SKETCH EXCERPTS FROM AAPS 10/14/19 ODRS COMMENTS

5/22/23

~~INSERT 1 (on Page 6)~~

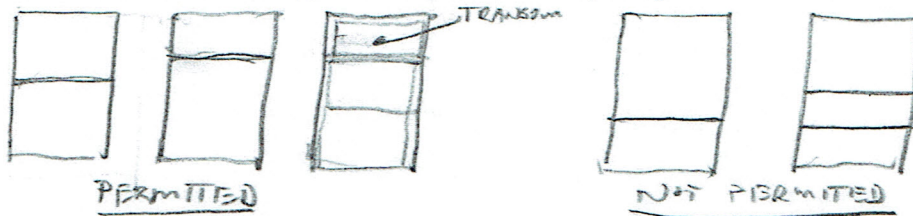
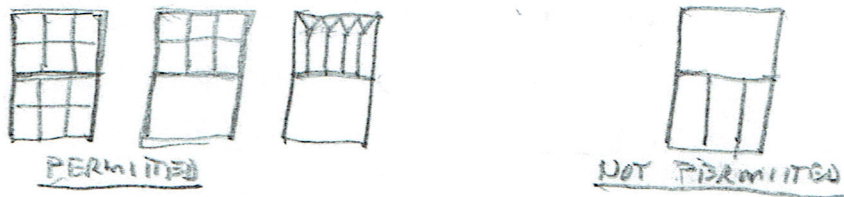
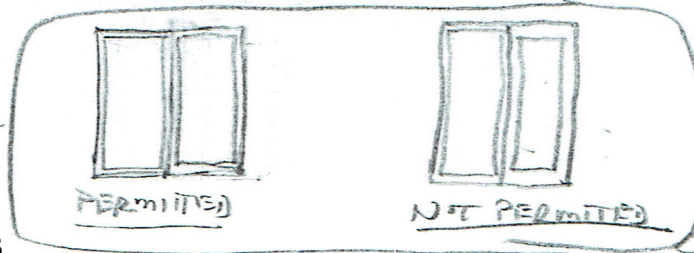
- A. For paired, triple or other grouped windows, all sash shall be separated by a wood or simulated wood vertical casing at least 5 1/2 inches wide, except where the architectural style is Art Deco, Streamline Modern or Moderne as defined in the Citywide Design Review Manual.

- B. Exterior screens, if any, on double hung or single hung windows shall cover both sash.

- C. Meeting rails for double hung or single hung windows and horizontal mullions for all windows shall be positioned in the upper 50% of the window opening.

- D. The dimensions shown on ^{Figure} Attachment 1 shall be the same for all sash within a window opening.

- F. Muntins, if used, shall be distributed in either a uniform pattern within each window opening or concentrated in the upper 50% of each opening.

- E. Horizontal slider windows are not permitted.

Attachment 2: Typical Dimensions of Wood and Steel Windows

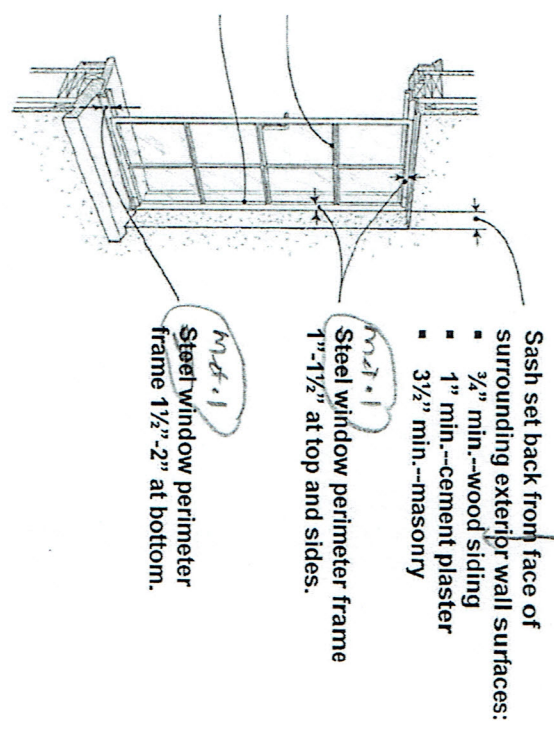
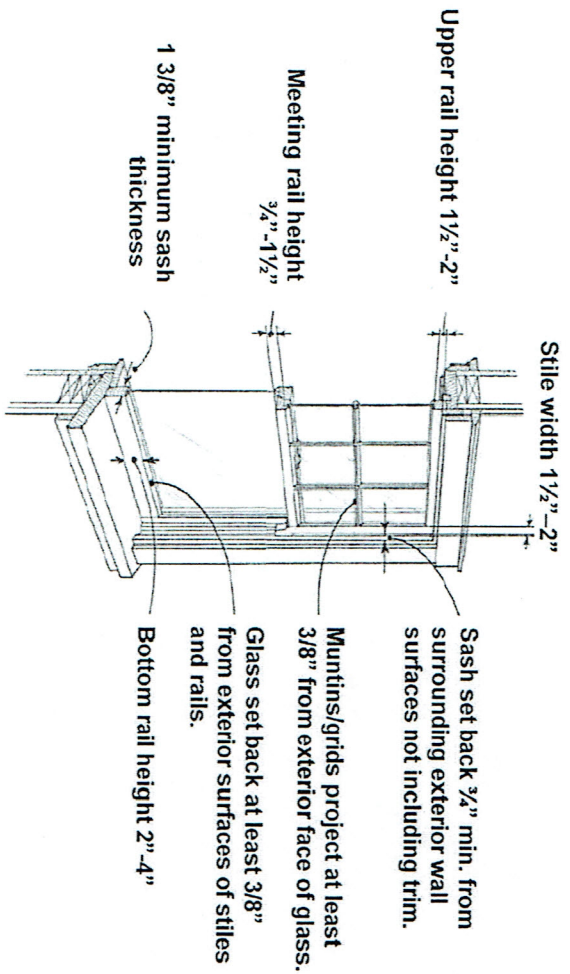
or simulated wood

I. Within each window opening, position sash, mullions and muntins in a symmetrical pattern.
